Houston Lighting & Power South Texas Project Electric Generating Station P. O. Box 289 Wadsworth, Texas 77483

January 5, 1990  
ST-HL-AE-3320  
File No.: G4.2,  
J41.3, G9.17  
10CFR50

South Texas Project Electric Generating Station  
Units 1 and 2  
Docket Nos. STN 50-498, STN 50-499  
Completion of Modifications to the Safety Parameter  
Display System (SPDS) for the First Refueling Outage

## DESCRIPTION OF NEW DISPLAYS AND OTHER SPDS DISPLAY MODIFICATIONS

FIGURE I-1  
NRAD DISPLAY

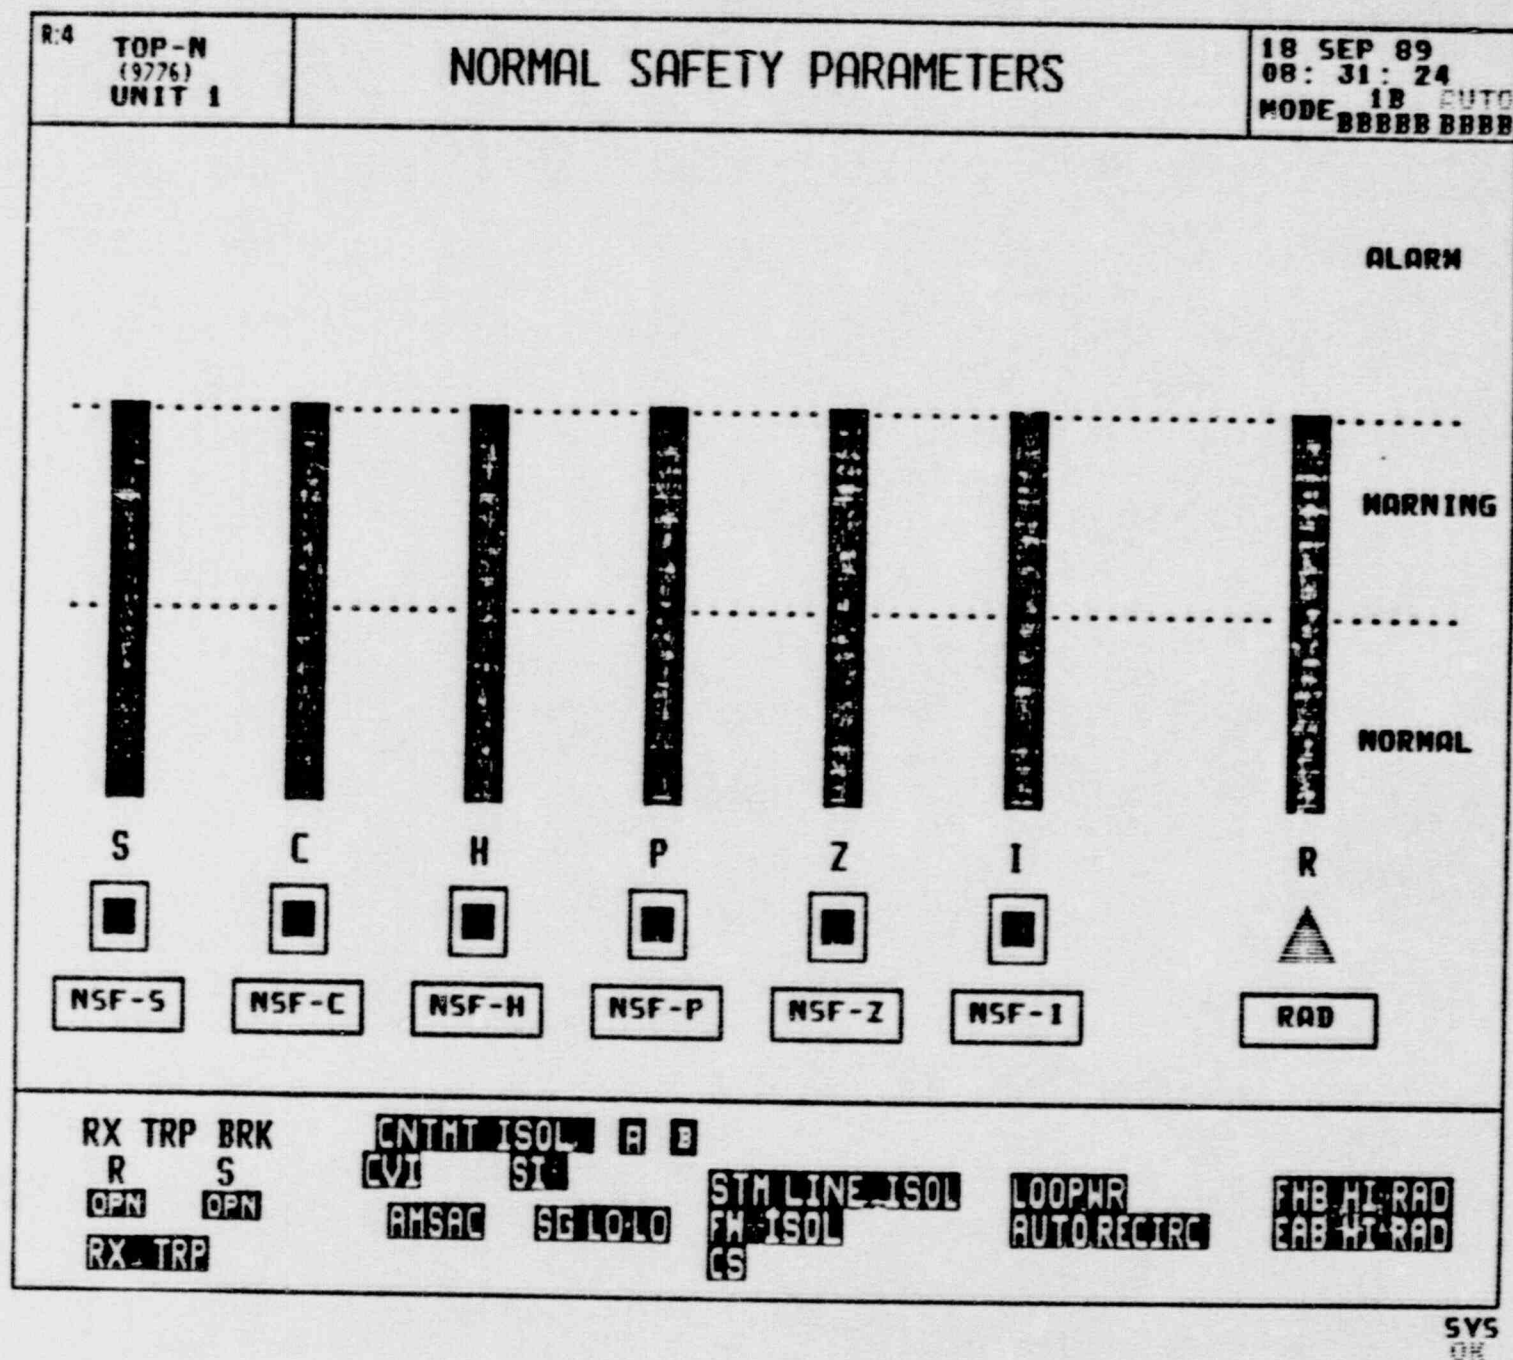
The normal radioactivity [NRAD] and critical radioactivity [CRAD] displays are shown in Figures I-1 and I-2, respectively. These displays have a similar layout to the other SPDS displays. The top left box of each display contains the display mnemonic, the display number, and South Texas Project (STP) unit number. The top middle box of each display contains the display name. The top right box of each display contains the date, time, and the plant operational mode.

The middle section of the Radioactivity Status displays provides the readings of the nine radiation monitors listed above in three rows of three, based on similarity of information provided and type of accident and/or release for which they provide a response or information. The overall format of these displays was coordinated with the Operations Department and reviewed in accordance with the STPEGS Control Room Design Review (CRDR) program.

The top three radiation monitors on the NRAD and CRAD displays, RCB PURGE, CR/EAB VENT, and SFP EXHAUST, are ESF actuation monitors and provide automatic responses to accidents.

The middle three radiation monitors, UNIT VENT, RCB ATMOSPHERE, and CNTMT HI RANGE, are release/containment monitors. These monitors provide information regarding breaches of the reactor coolant system boundary and regarding releases from the plant to offsite.

The bottom three radiation monitors, COND VAC PUMP, MAIN STM LINE, and SG BLOWDOWN, provide information useful in identifying a steam generator tube rupture accident.

FIGURE I-3  
TOP-N DISPLAY

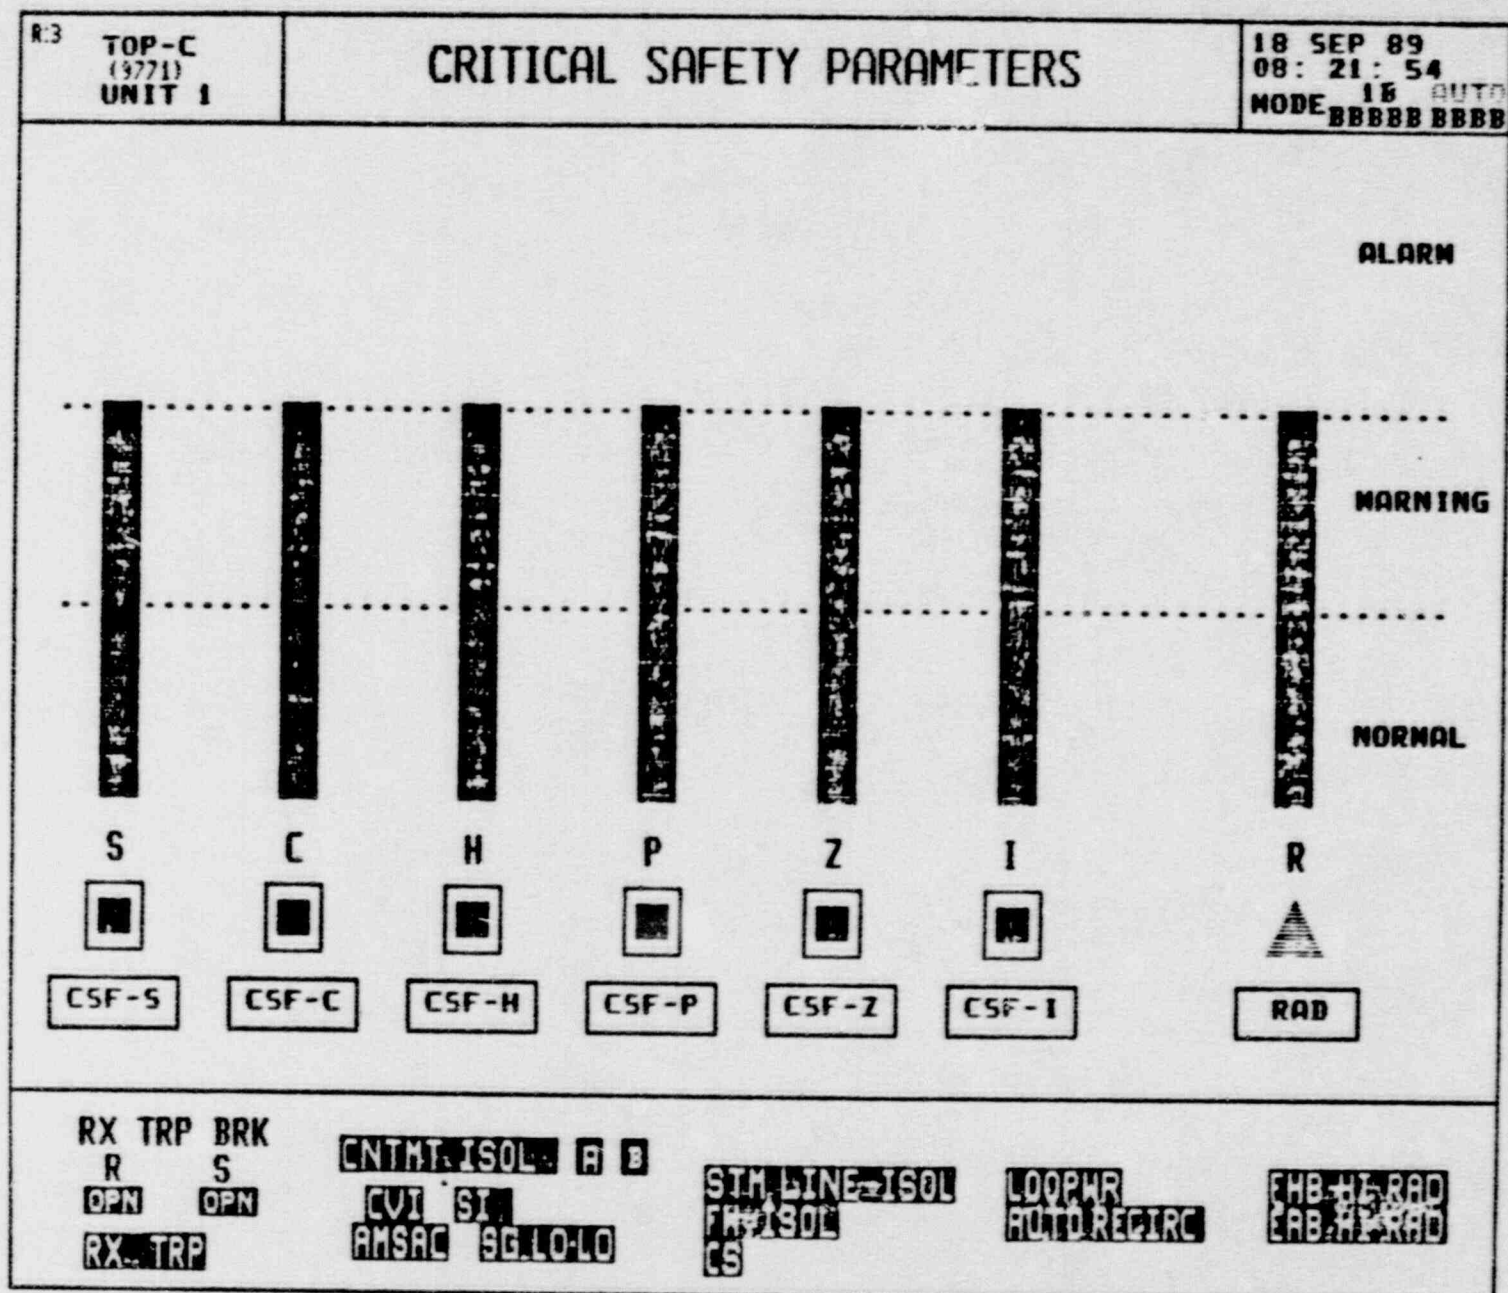
Both the Top Level Normal Safety Function (TOP-N) and Top Level Critical Safety Function (TOP-C) displays previously contained six status bars, one for each of the six safety functions, Subcriticality [S], Core Cooling [C], Heat Sink [H], Integrity [P], Containment [Z], and Inventory [I]. A status bar for Radioactivity [R] has been added to both the TOP-N and TOP-C displays. This status bar is located at the right of the display, separated from the other six safety function bars. It is identified underneath with an "R", a solid triangle status indicator, and "RAD". Figures I-3 and I-4 show the revised TOP-N AND TOP-C displays, respectively.

FIGURE I-5  
TYPICAL MID-LEVEL DISPLAY

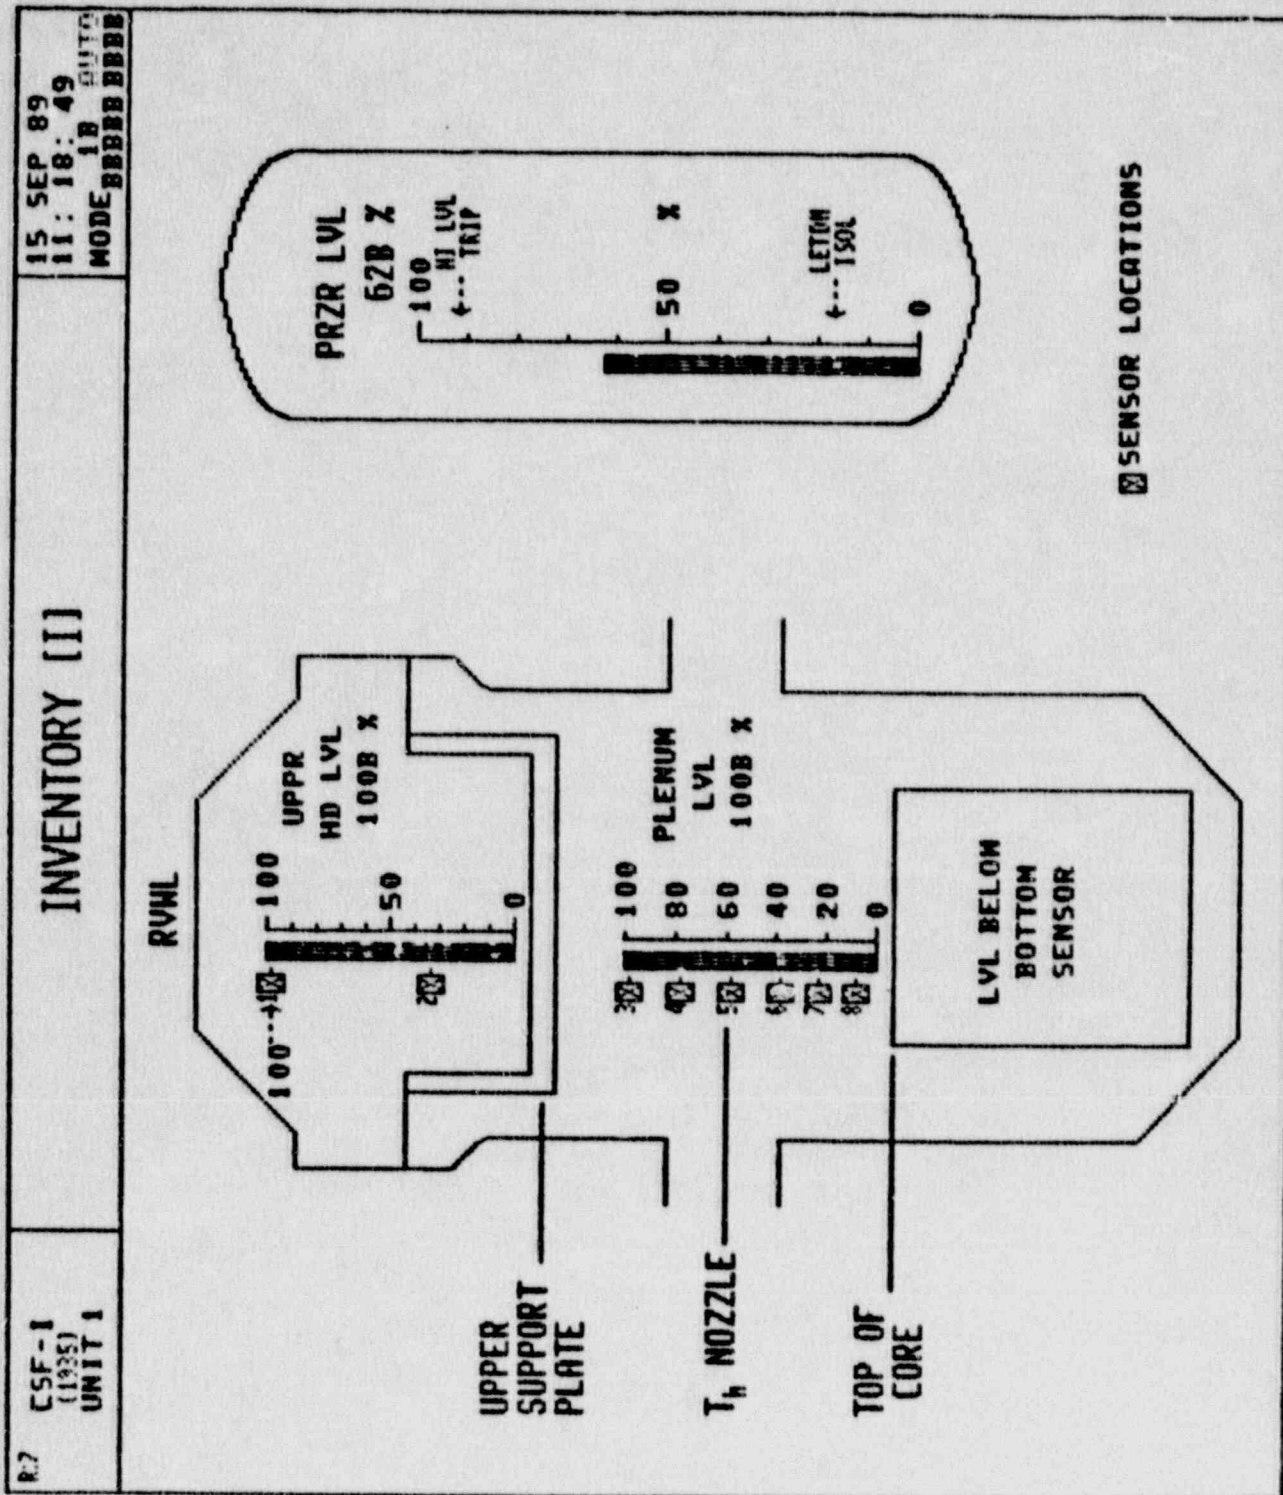
All SPDS and ERFDADS displays containing the safety status boxes were also revised to include the Radioactivity [R] status indicator. This status indicator was added in the bottom left section, as a solid triangle to the right of the six safety function boxes with the letter "R" to the right of the triangle. Figure I-5 shows a typical display with the addition of the radioactivity safety status indicator.

FIGURE II-2  
FUNCTION KEYPAD

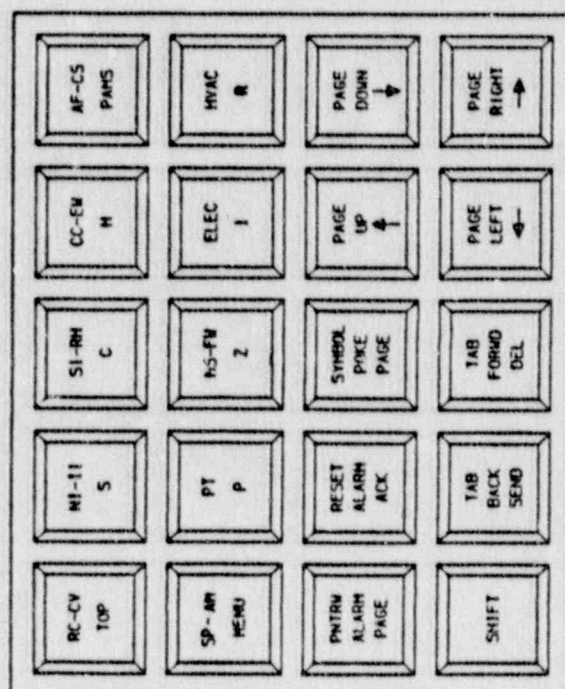
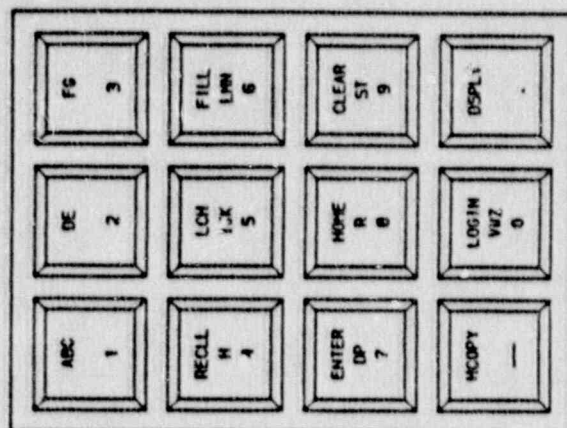
The revised keyboard and keypad layouts are shown on Figures II-1 and II-2, respectively.

The mid-level function key "R" is located on the keypads to the right of function key "I". The seven mid-level function keys are located within the top two rows of the left face of the keypads.
